Addendum #3

Date: January 18, 2019

PROJECT #: ES-0042-C01

DESCRIPTION: Orange High School Addition & Renovation

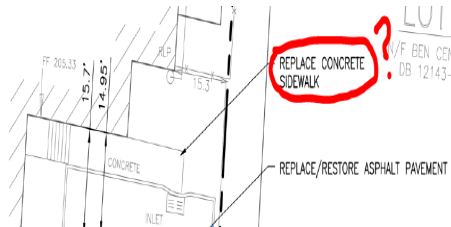
35. **Question:** Various = The 8 shown on C-2.1 [assuming there are (2) on Lincoln Ave.]

There are various concrete driveway “aprons”/entrances. What are the construction details? Same as 10/C-8.0 Concrete Sidewalk Details? or other?

Answer: The plans depict a total of six driveway aprons—two on Clarendon Place, two on Lighthipe Place, and two on Lincoln Ave (1 new and replacement of existing). See revised Drawing C-8.3, Site Details, issued in Addendum #2 as Attachment 2.44. Concrete driveway aprons shall be 6" thick 4500 psi concrete, with 1 layer of 6"x6" W1.4xW1.4 galvanized mesh and 4" thick compacted DGA base.
